BELMONT MIDDLE AND HIGH SCHOOL BUILDING COMMITTEE

SEPTEMBER 11 2019

UPDATED EXTERIOR VE ITEMS

SITE IMPROVEMENTS - PROVIDE ALUMINUM BENCHING

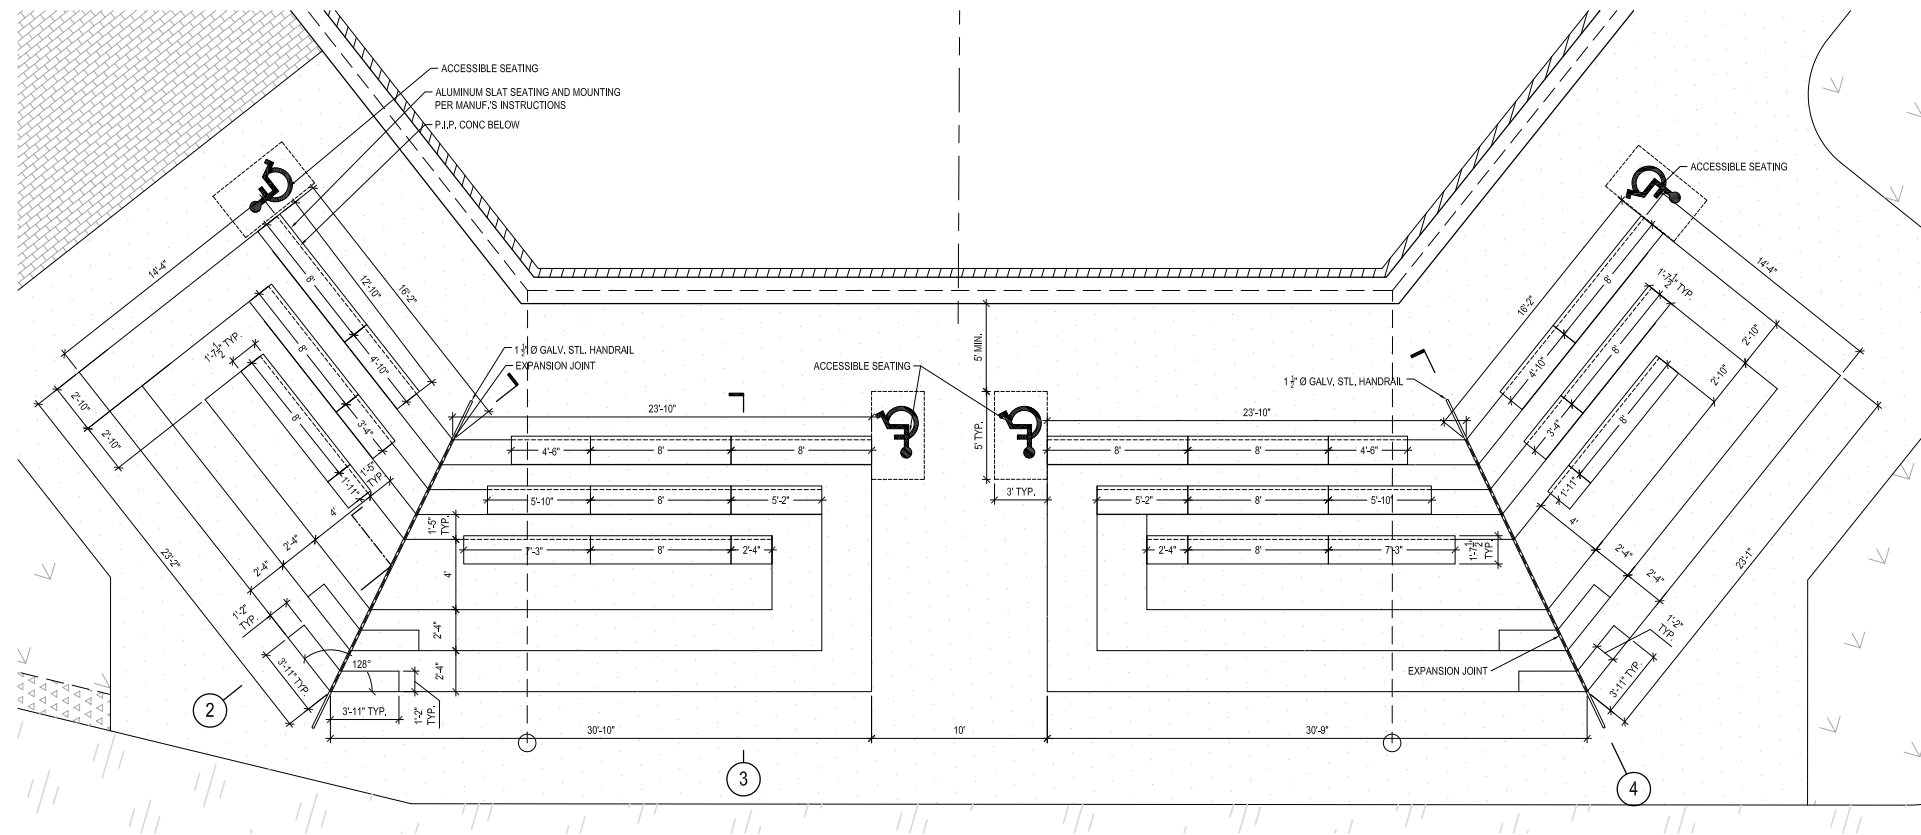
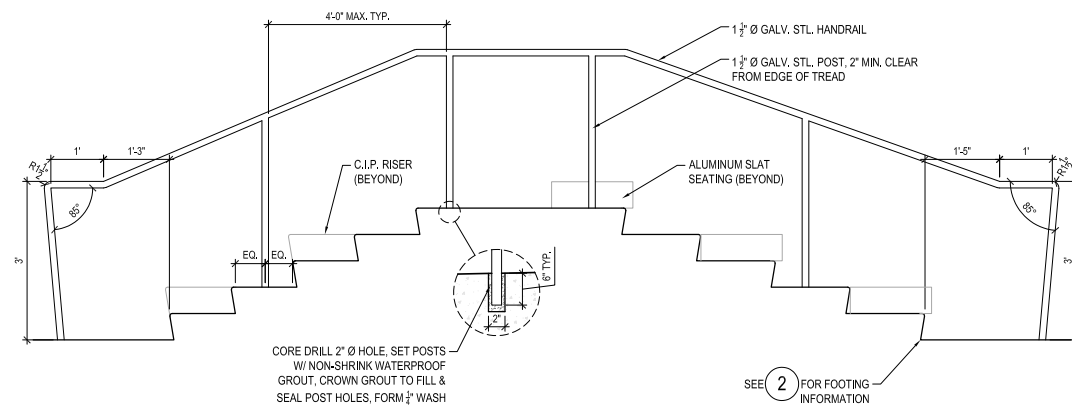
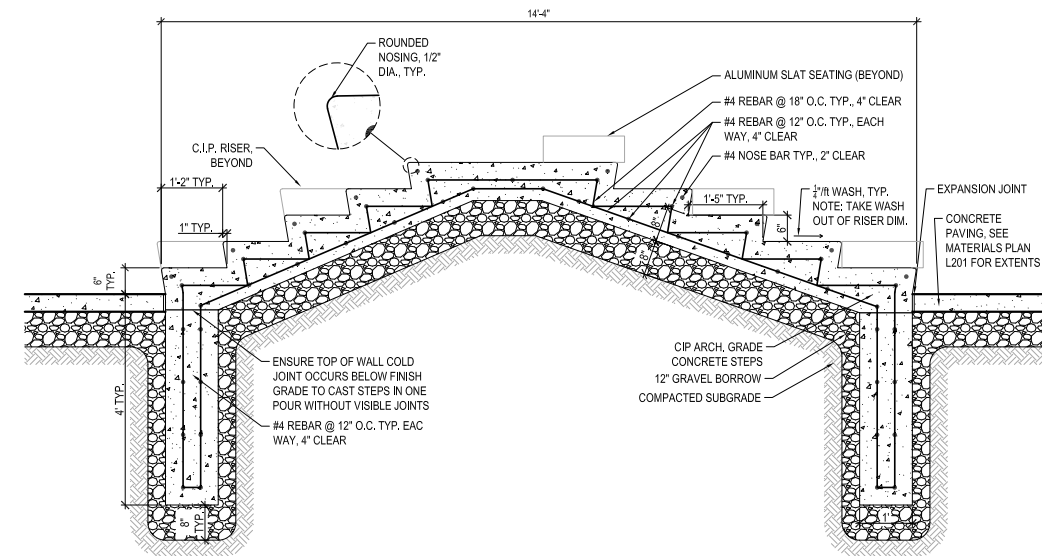
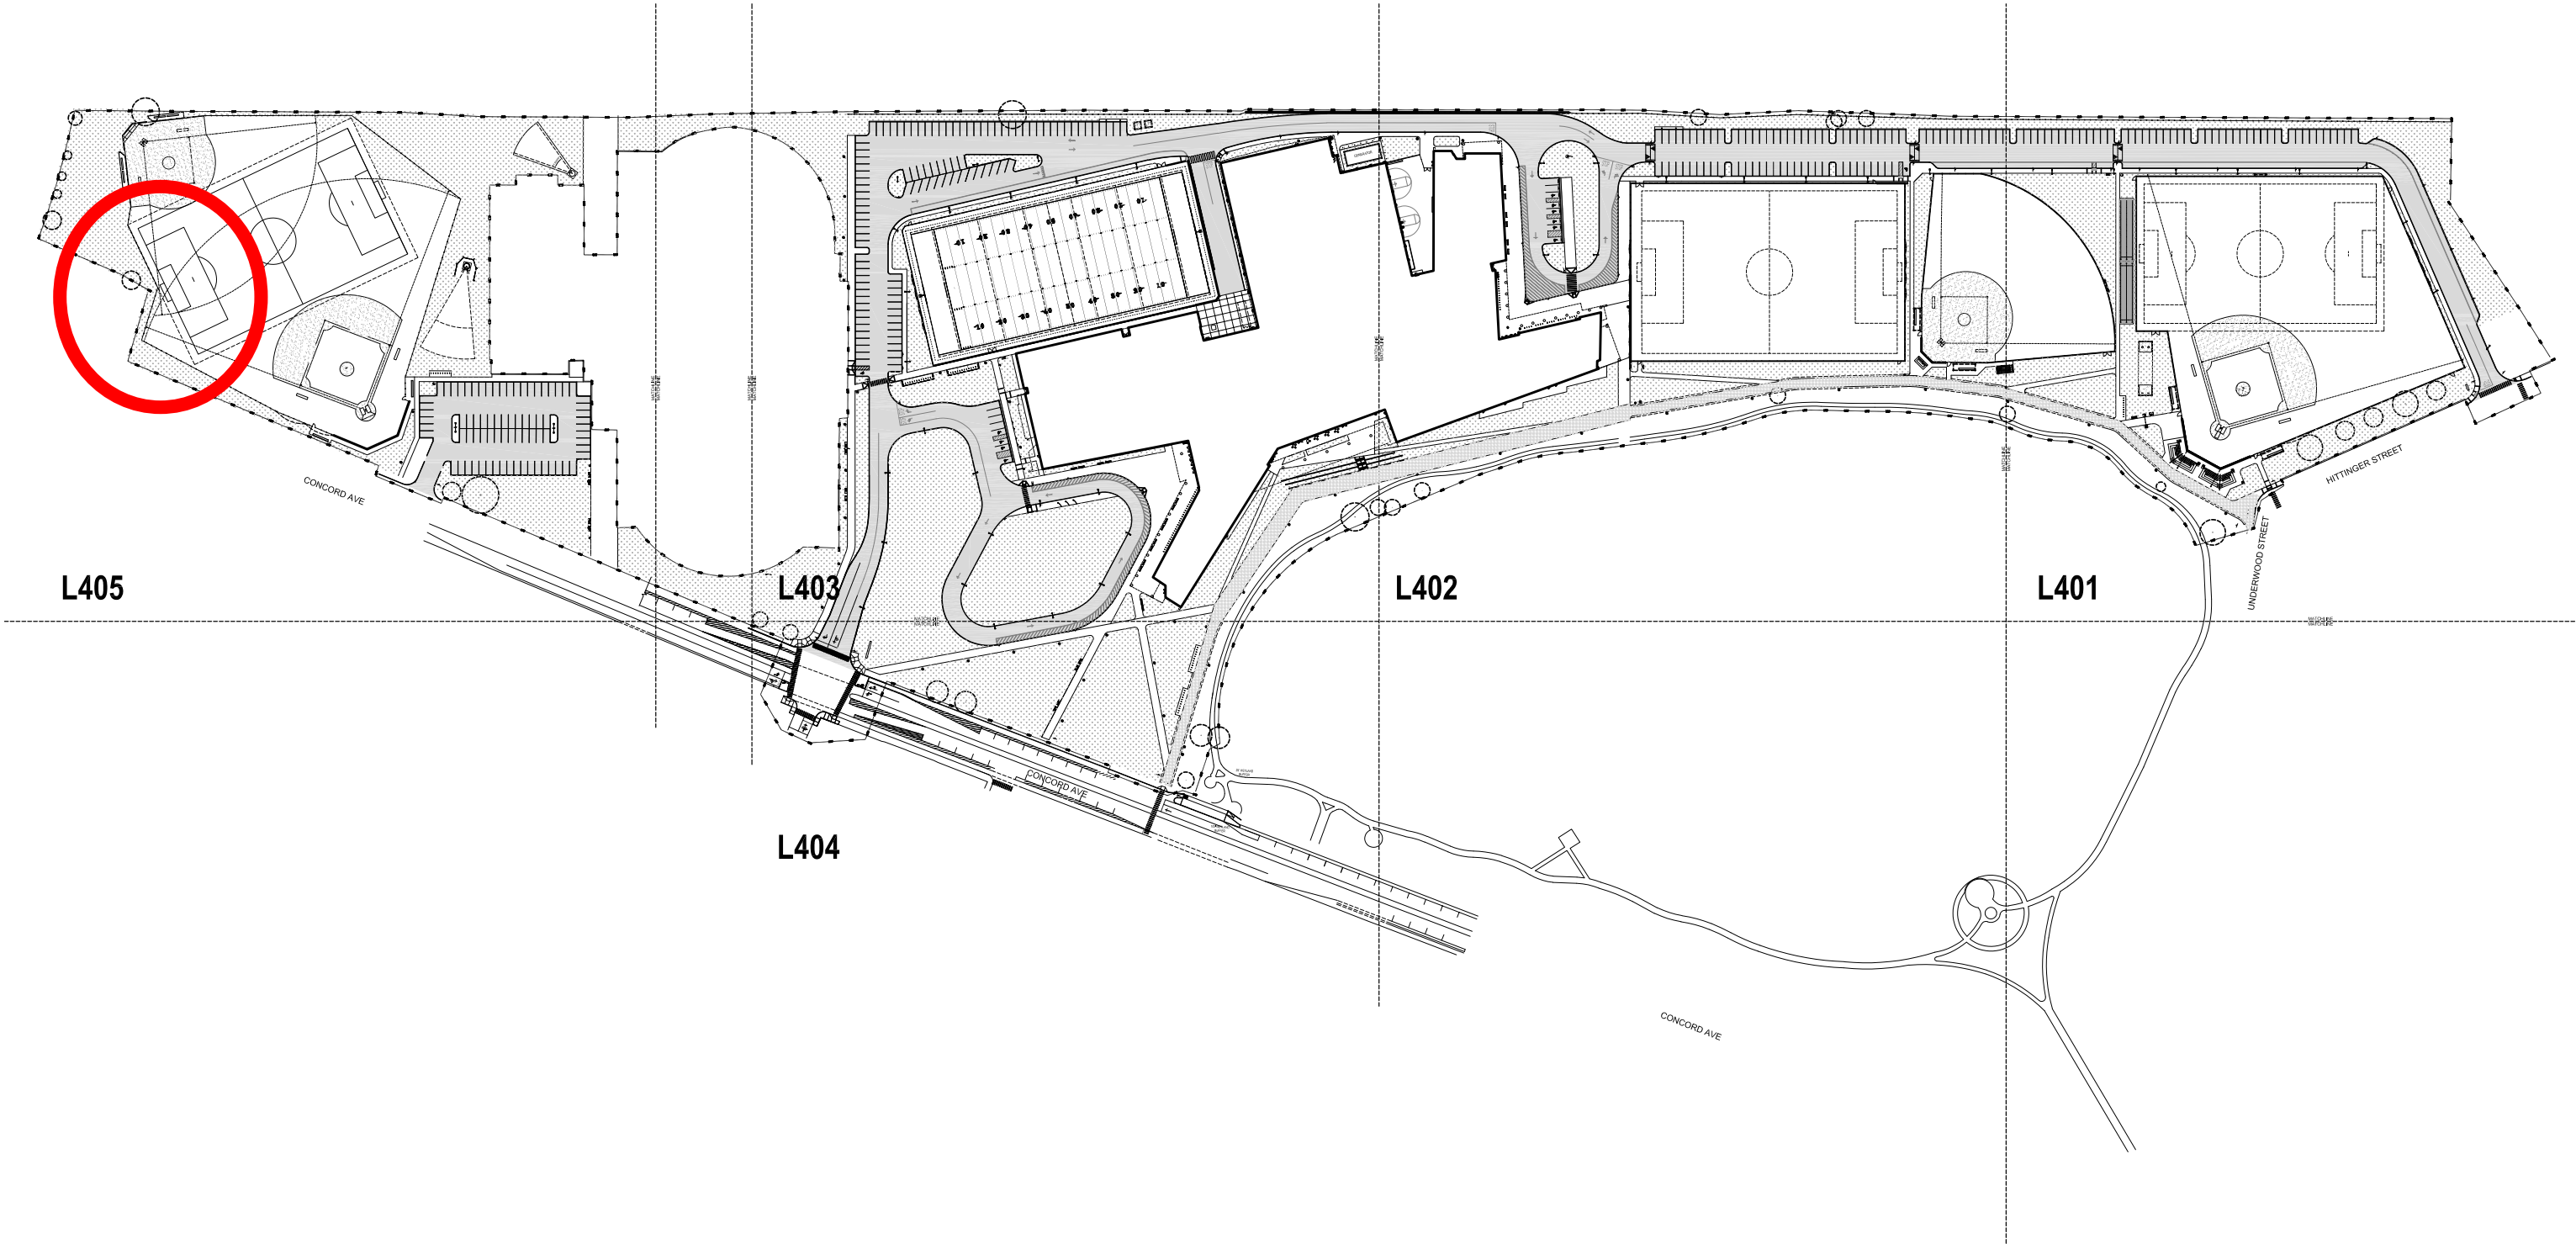
CURRENT DESIGN

VE PROPOSAL

SITE IMPROVEMENTS - PROVIDE STANDARD NYLON SPORTS NETTING

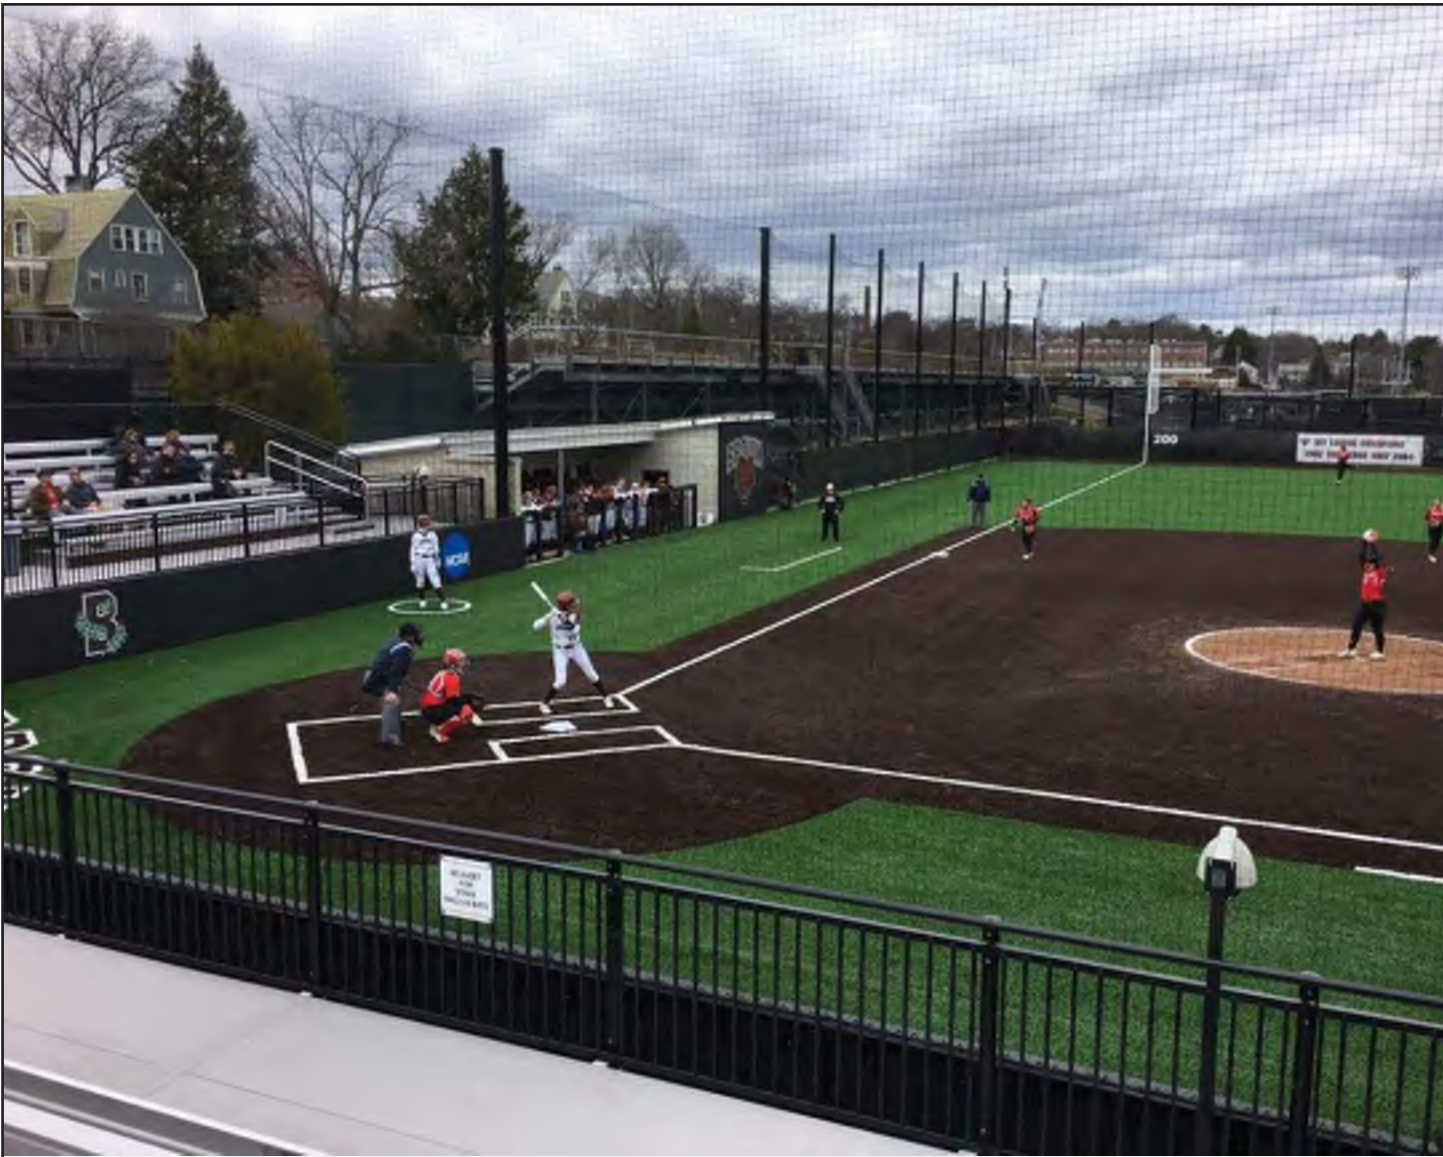
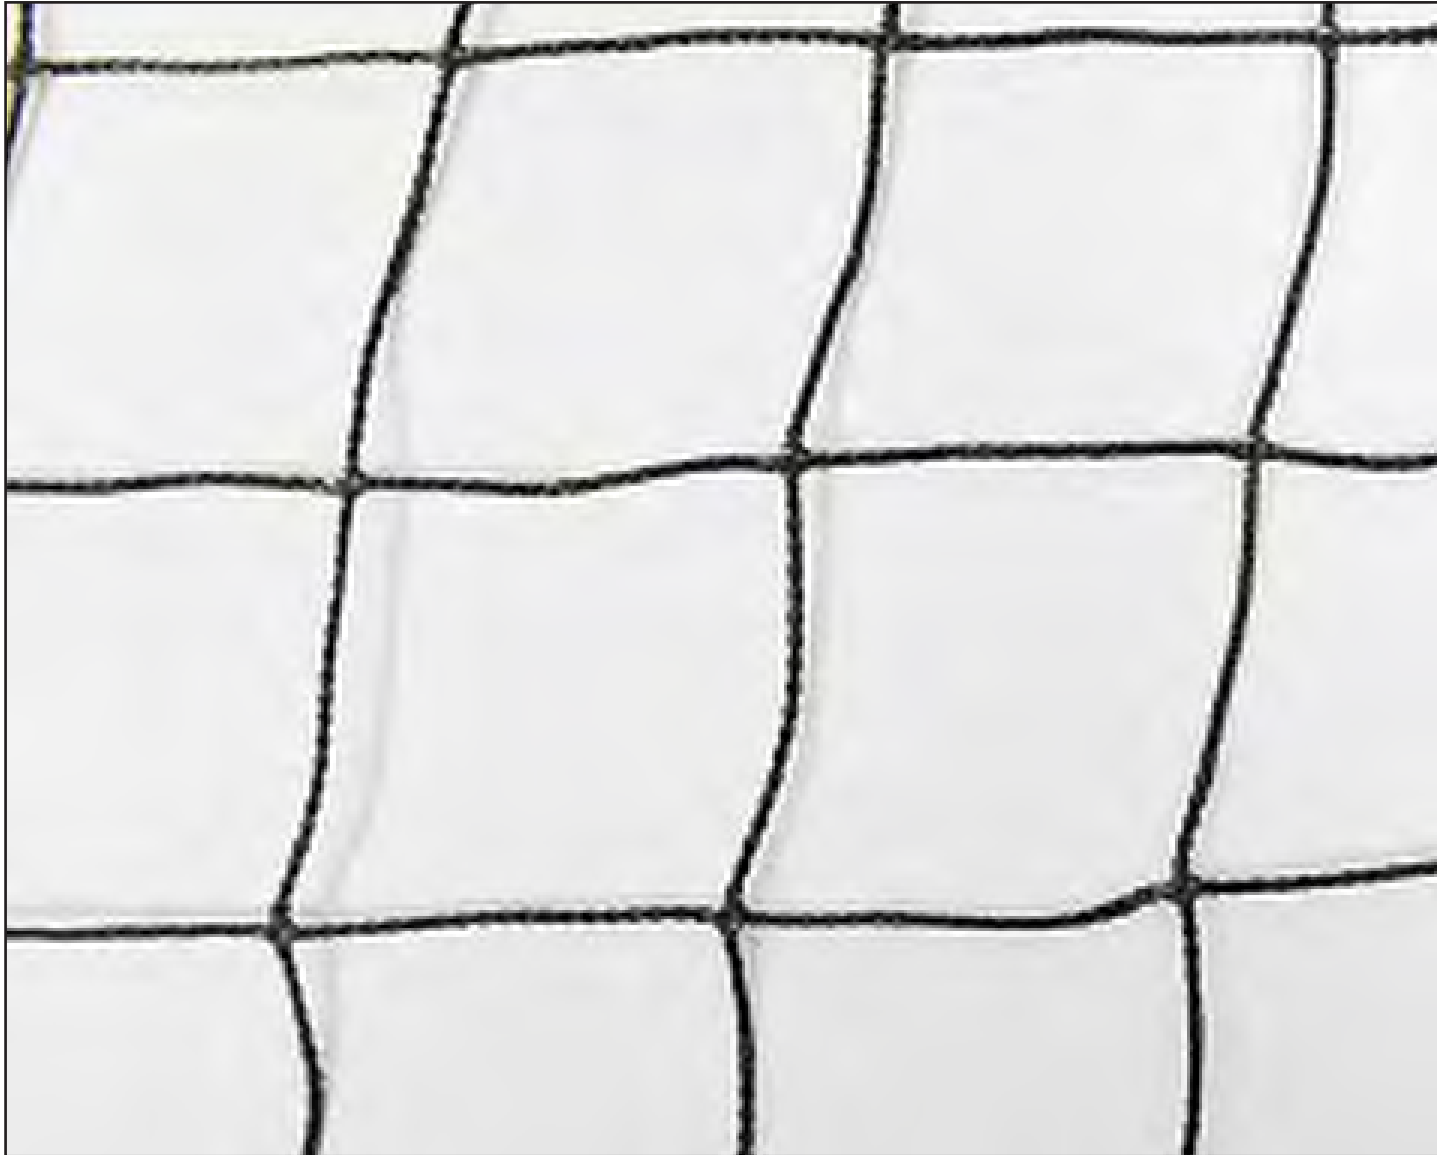
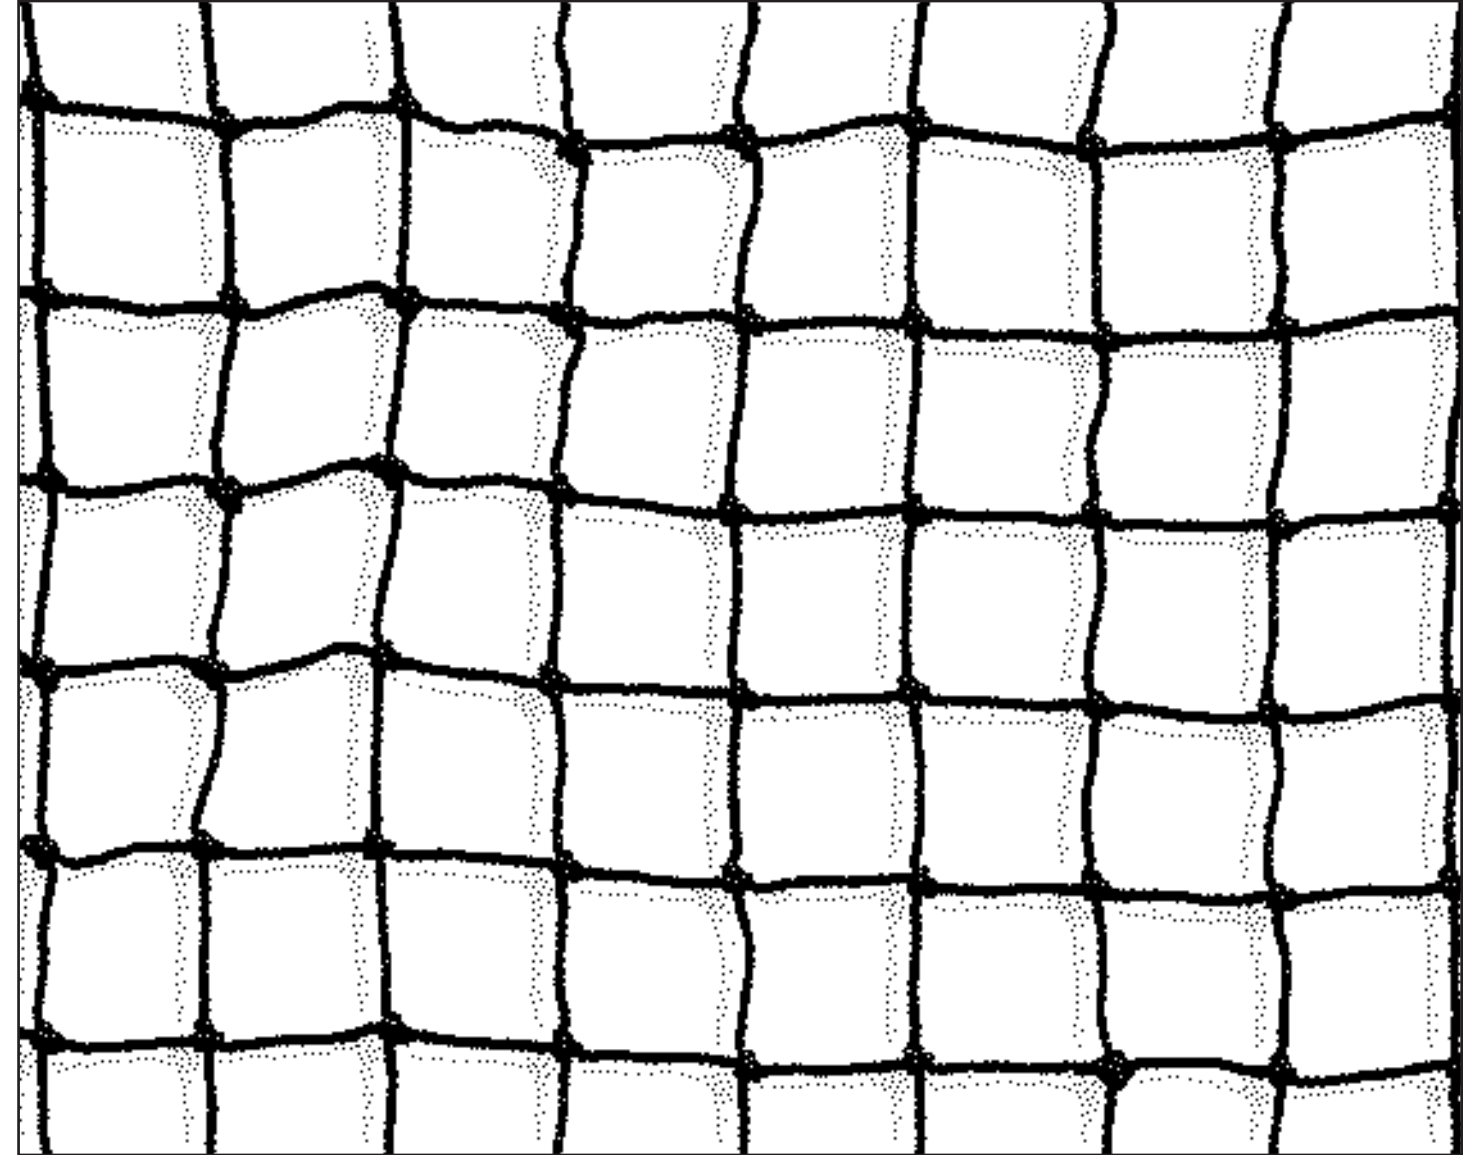
CURRENT DESIGN - KNOTLESS DYNEEMA

VE PROPOSAL - KNOTTED
